1st Further Information

**Proposed Temporary Warehouse (excluding Dangerous Goods Godown) with Ancillary Facilities
and Associated Filling of Land for a Period of 3 Years in "Agriculture" Zone,
Lot 207 in D.D. 38, Man Uk Pin, New Territories**

(S.16 Planning Application No. A/NE-MUP/235)

Response to CEO, CEDD comments on 25 June 2026.

FIGURE 1

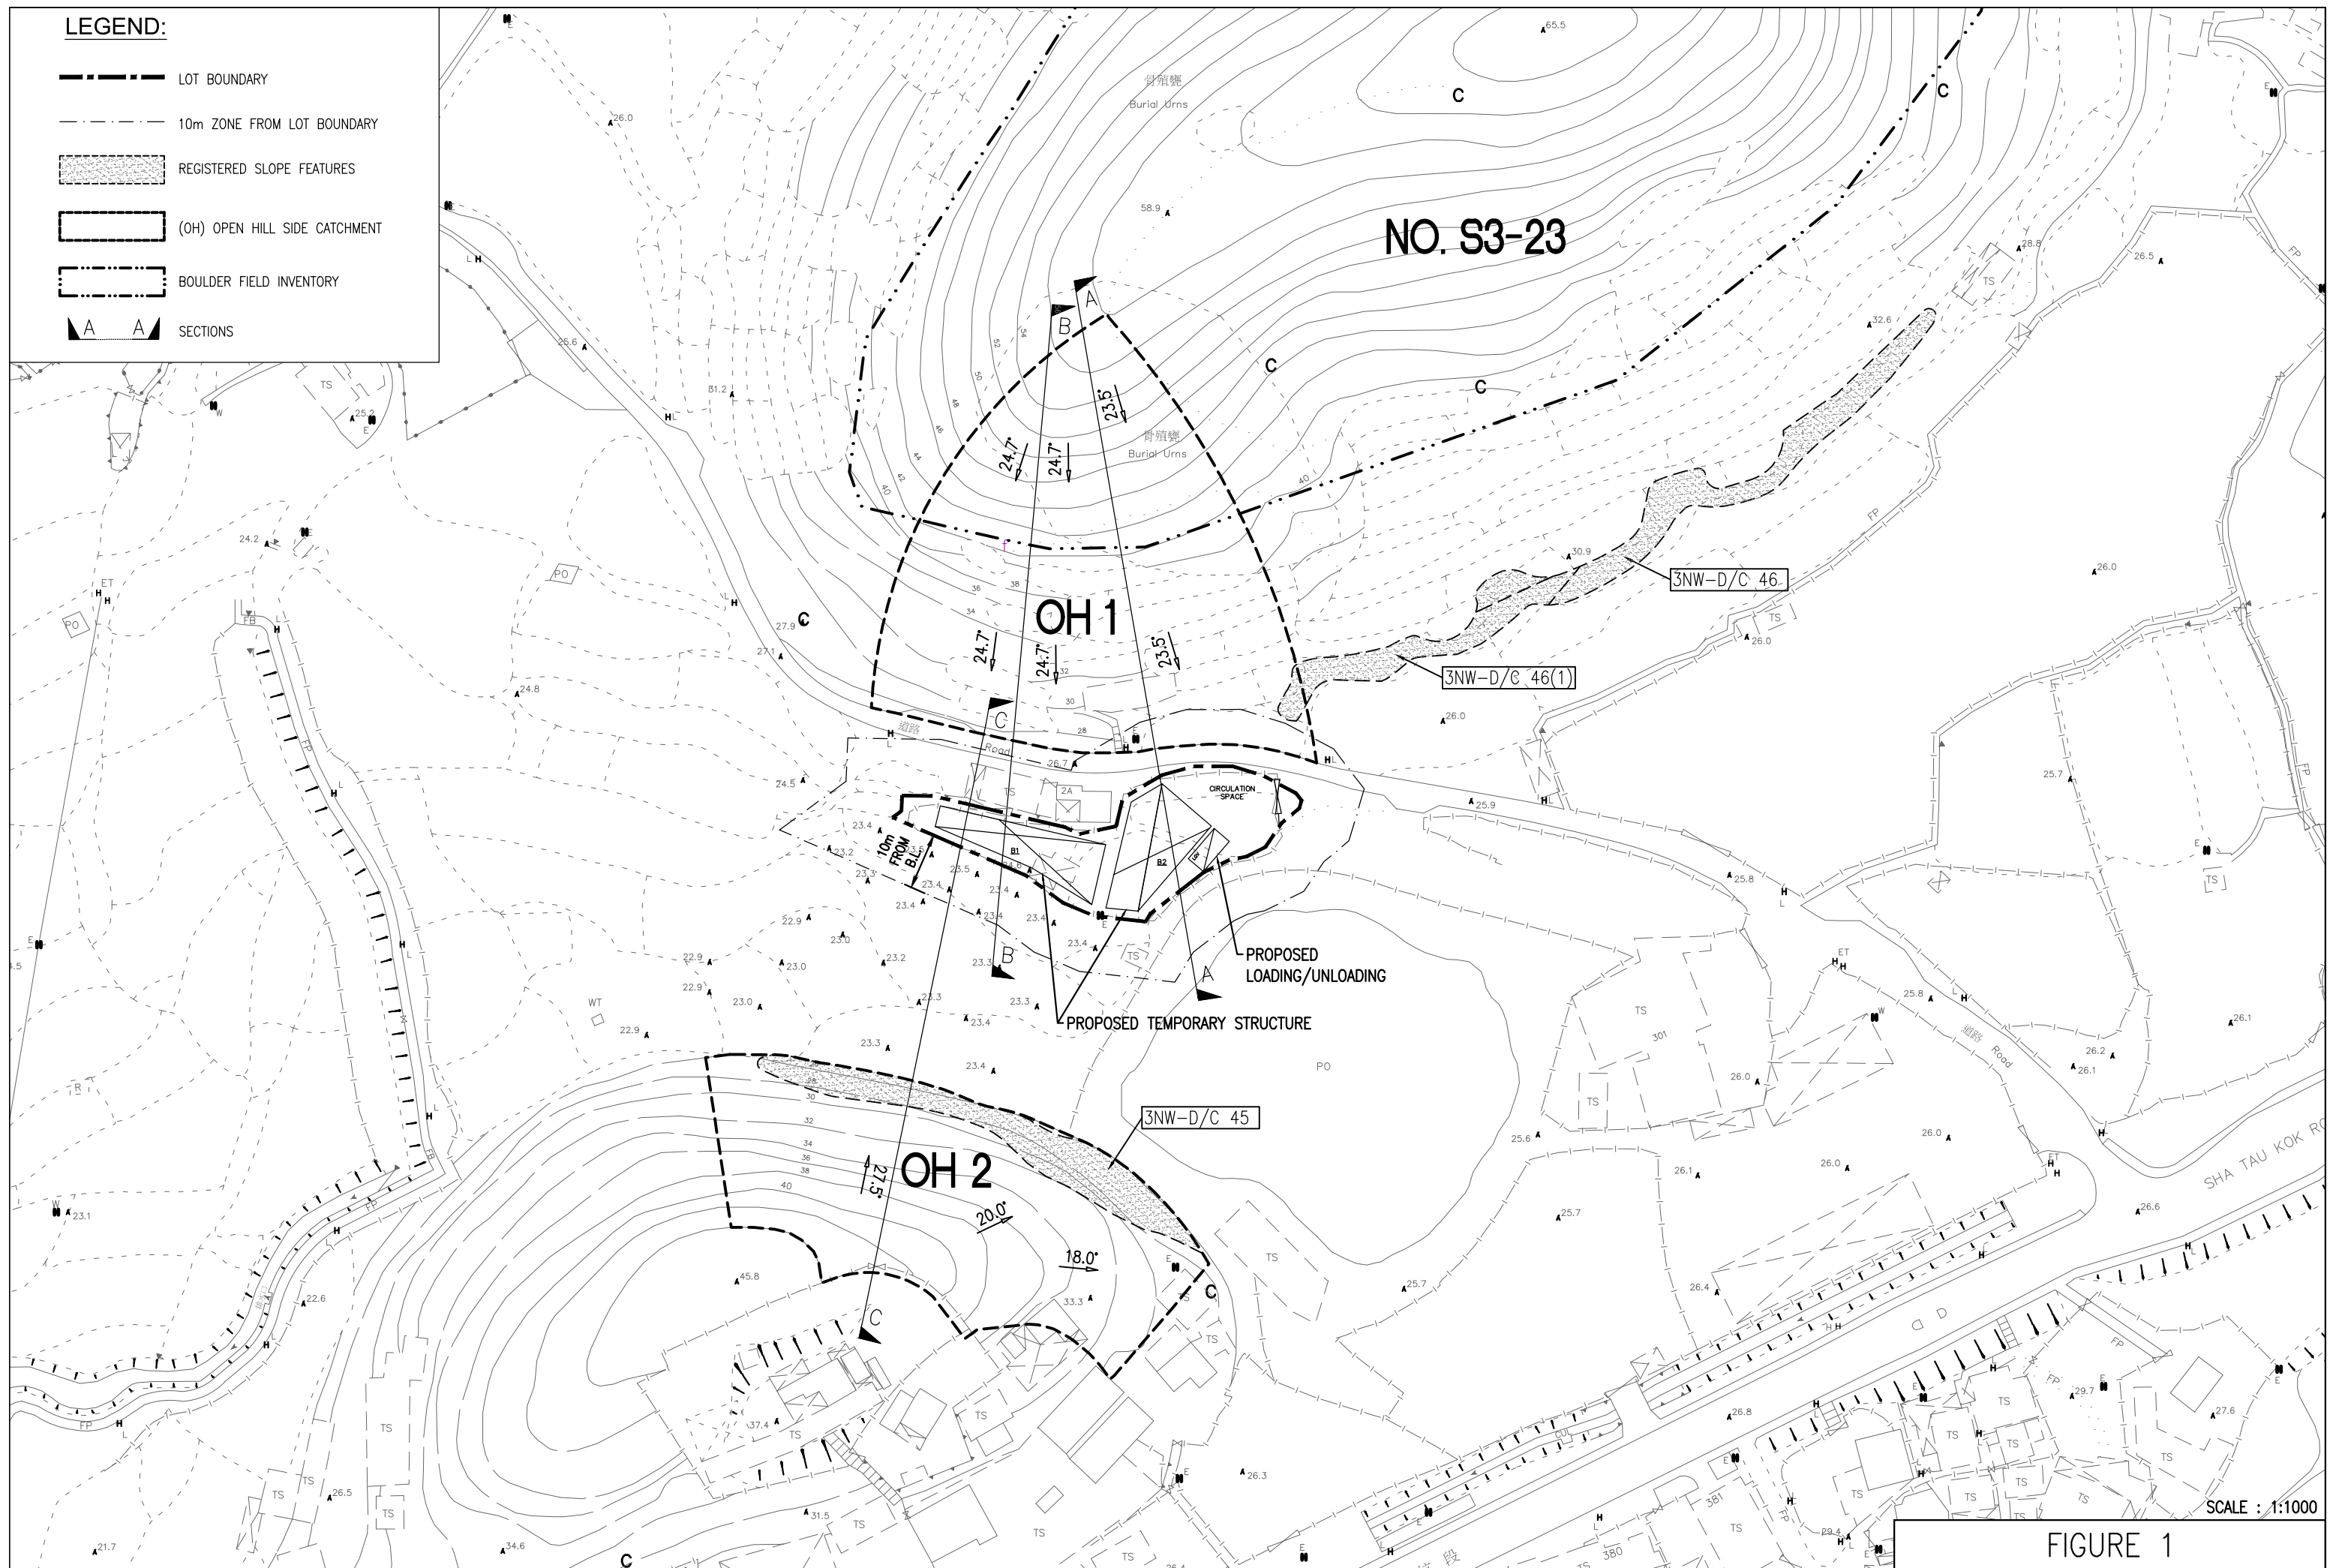
Comment from GEO, CEDD	Response to Comment (R to C)
The subject site is overlooked by steep natural terrain and meets the alert criteria for a natural terrain hazard study (NTHS);	Noted. This Report has been prepared in accordance with GEO Report 136.
Given the temporary nature and the proposed use as warehouse of the subject site, the requirement for NTHS might make the case not economically viable. As an alternative, the northern part of the subject site may be designated as a ‘no-build’ zone, within which no critical facilities (i.e. facilities under Group 1 to 3 in the attached table at Appendix II) should be located. In particular, the proposed site office, washroom, parking space and manned structure (if any) should be located away from the ‘no-build’ zone. The suggested extent of the ‘no-build’ zone is shown in the attached plan. With the inclusion of the ‘no-build’ zone, the requirement for NTHS may be waived;	Noted. Since the indicated no-build zone will render the development totally ineffective and impractical, we propose that an NTHS shall be carried out to the Study Area proposed in Section 4.3 of this Report.

Section 3.1.3 of the GPRR - the applicant should discuss the boulder field inventory information for the natural terrain overlooking the subject site;	Noted. The discussion of boulder field inventory information has been revised accordingly in Section 3.1.3.
section 4.2.1 of the GPRR - relaxation of angular elevation of the Alert Criteria from 20 degrees to 25 degrees could not be applied for the natural terrain to the north of the subject site as the natural terrain is affected by human disturbance (e.g. terraces) and is considered to be a Hillside Pocket; and	Noted. The angular elevation of the Alert Criteria is revised to 20 degrees.
Section 4.2.2 of the GPRR - the applicant should discuss the facility group of the proposed site office, washroom and parking space of the proposed use.	Noted. Referring to the revise Layout Plan, only Loading/Unloading space (LGV) and warehouse for goods storage are proposed. The discussion of the facilities are revised in Section 4.2.

4.1 Description of the Catchment Areas (Figure 1 & 5)

The subject Site is overlooked by natural terrain on its north and south side. Based on available topographic maps No. 3 NW-25B of Hong Kong from the Survey & Mapping Office (SMO) of the Lands Department, the hillside catchments are described below, and presented as Figure 1, with relevant cross-sections of the catchment presented as Figure 2 to 4. An overall photographic plan view of the Catchments and the Site as shown in Figure 5.

- (a) Catchment OH1 (Natural openhill terrain) - the majority portion of this catchment is characterized by gentle sloping terrains i.e. $< 25^\circ$. There is a burial urns area covered the upper hillside terrain from +38.0mPD to 58.0mPD with the hillside gently sloping at 24.7° . Near bottom of this Catchment at approximately 30mPD, the area has been flattened to house an existing temporary structure which shield off proposed B2 warehouse from the Catchment. An existing narrow excess road run along the Catchment toe line, on the other side of this access road, there are other existing structures which shield off proposed B1 warehouse from this Catchment.

LAYOUT PLAN

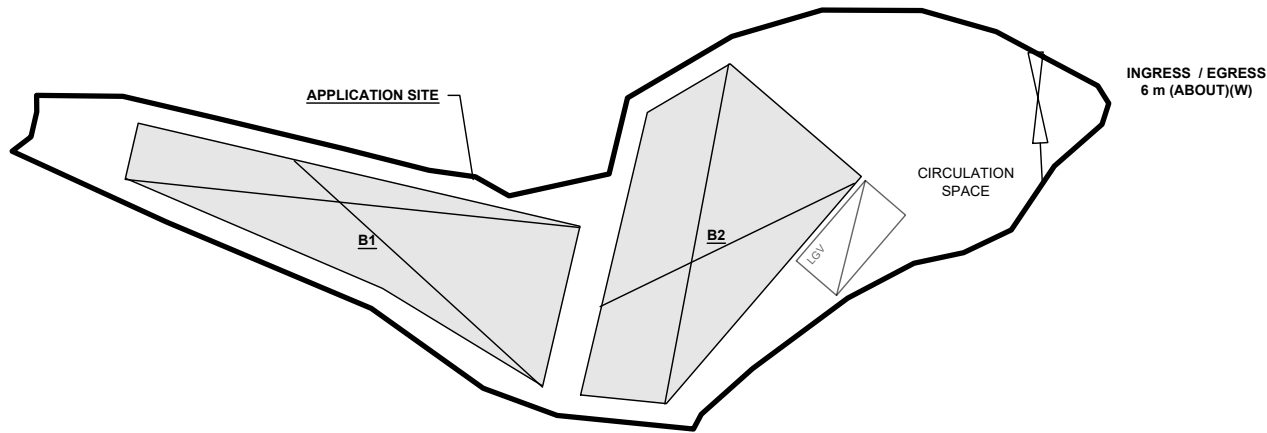
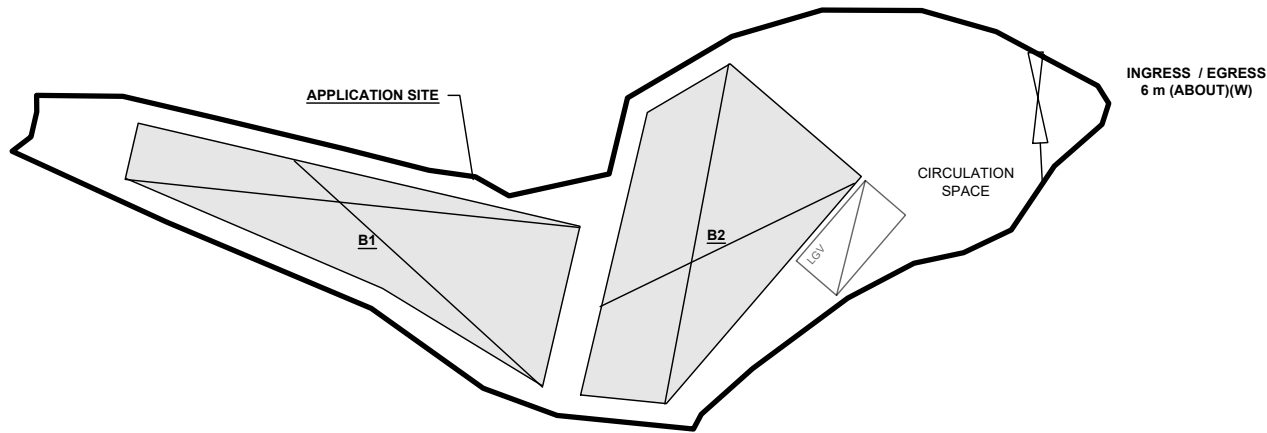
Departmental Comments		Applicant's Responses
1. Comments of the Commissioner for Transport (C for T)		
(a)	The applicant shall advise the provision of pedestrian facilities and management measures to ensure pedestrian safety.	As mentioned in Section 3.4 of the Planning Statement, staff will be deployed to station at the vehicular ingress/egress to direct incoming/outgoing vehicles to enhance pedestrian safety and road safety.

(b)	The applicant shall advise the management/control measures to be implemented to ensure no queuing of vehicles outside the application site.	The swept path analysis has demonstrated that there is sufficient space for vehicles to manoeuvre smoothly therewithin, such that no vehicles will be allowed to queue back to or reverse onto/from the proposed development to the local access.

Further to the revised layout plan, the facilities of the proposed Development include a Warehouse and a loading/unloading space only. Referring to Table 2.2 Group of Facilities, the groupings of the facilities are shown in the following table.

Appendix C

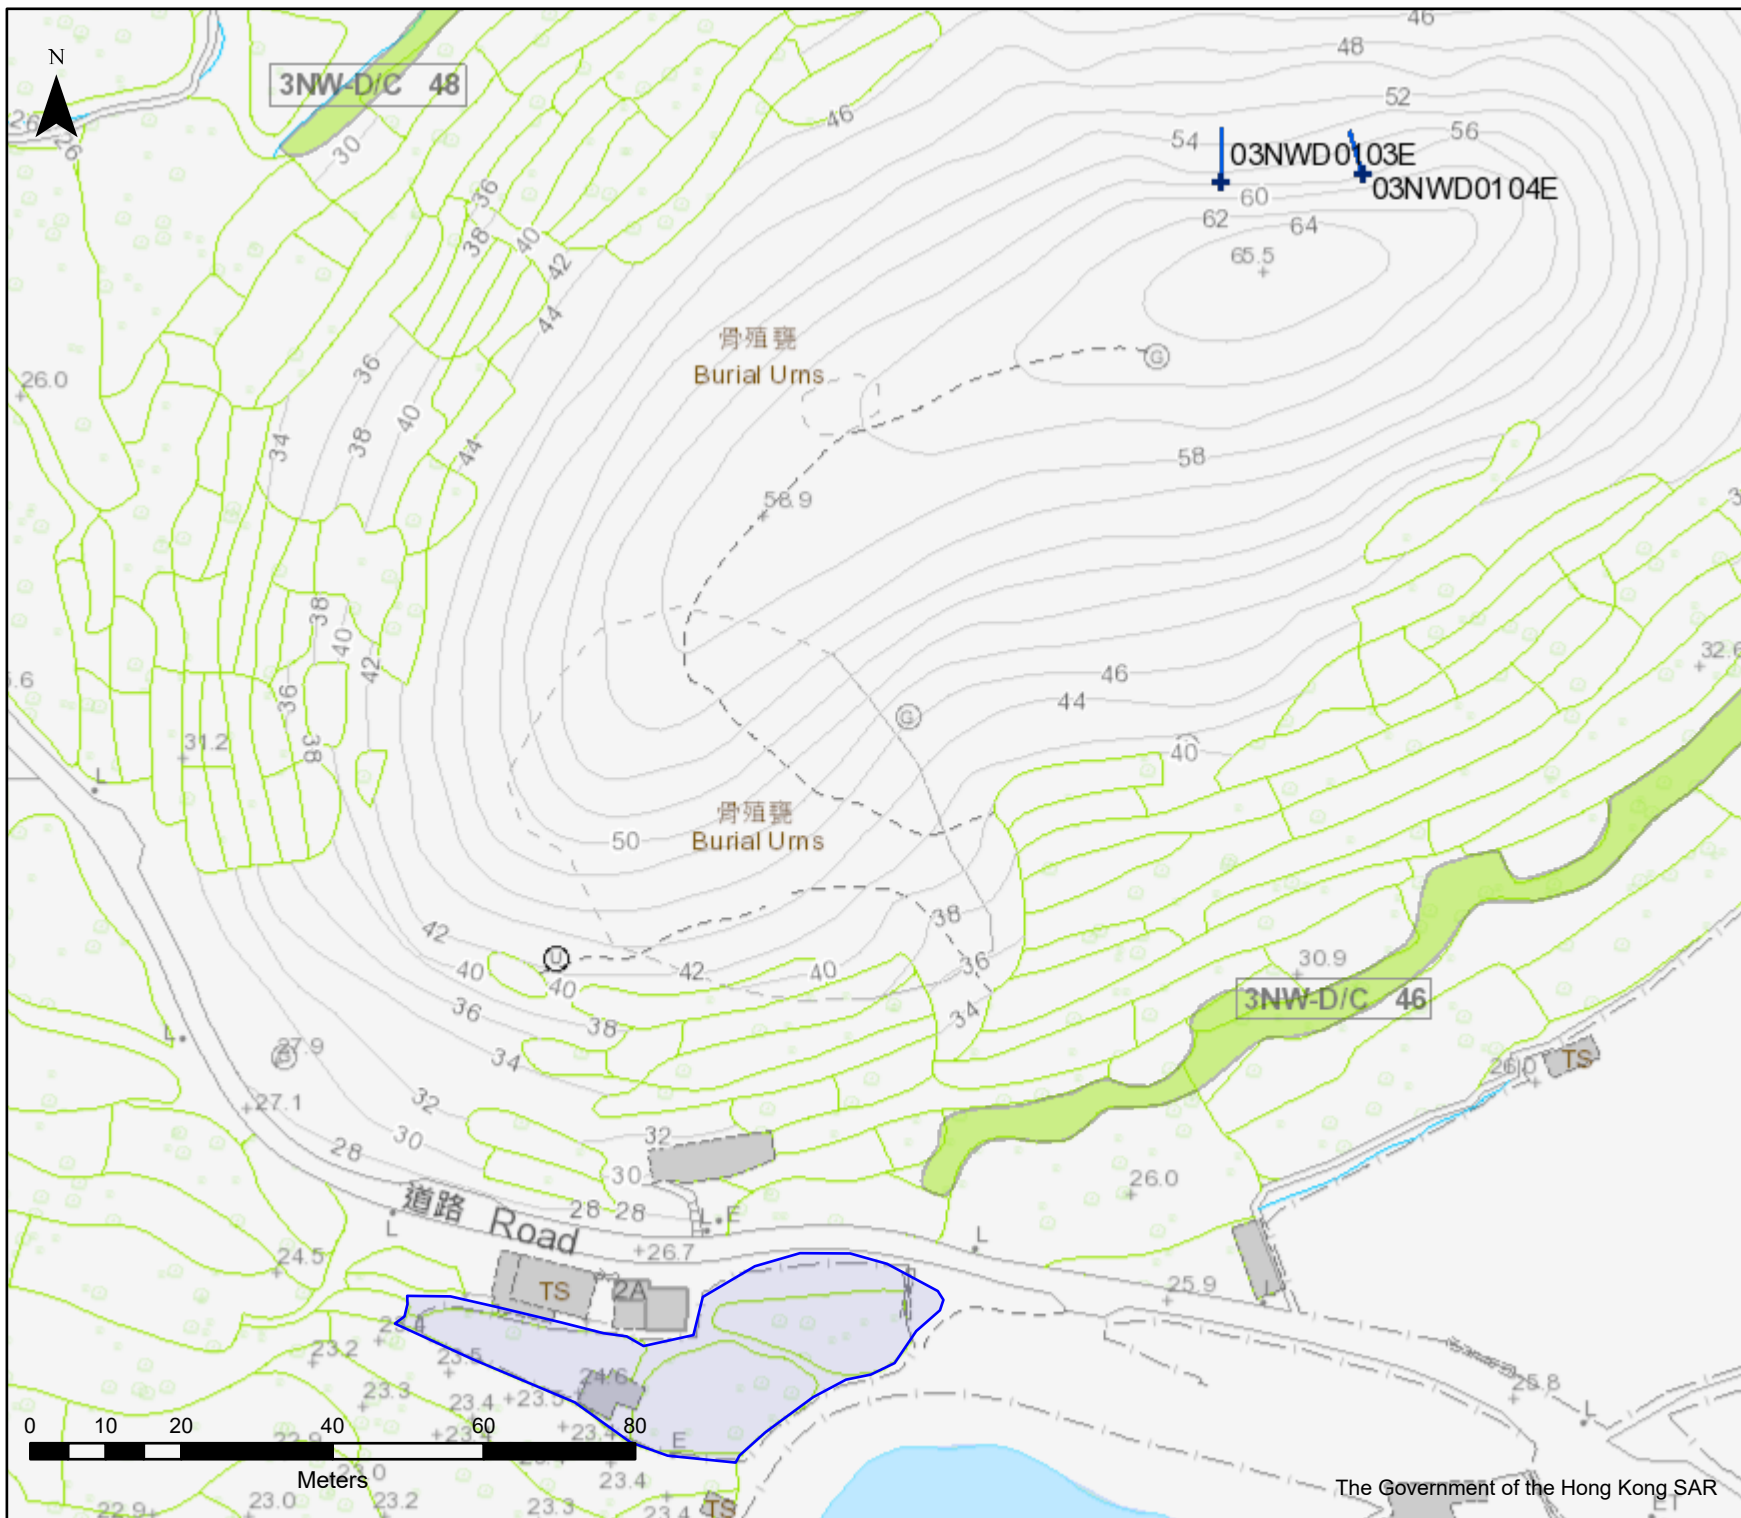
Section 3.1.1 of the GPRR - there is no alluvium within the subject site according to the geological map in Appendix C of the GPRR. the applicant should revise;	Noted. The top layer of soil should be Colluvium. Section 3.1.1 is revised accordingly.

Based on Glnfo Geological Map of Solid Geology, there is no available ground investigation results within the Site and its adjacent area (sheet 3 of geological map), the Site is lying on Debris Flow Deposits (Qpd) stratum, the top layer of soil would be colluvium.

The geological map 1st Ed, Before 1995 is attached in **Appendix C**.
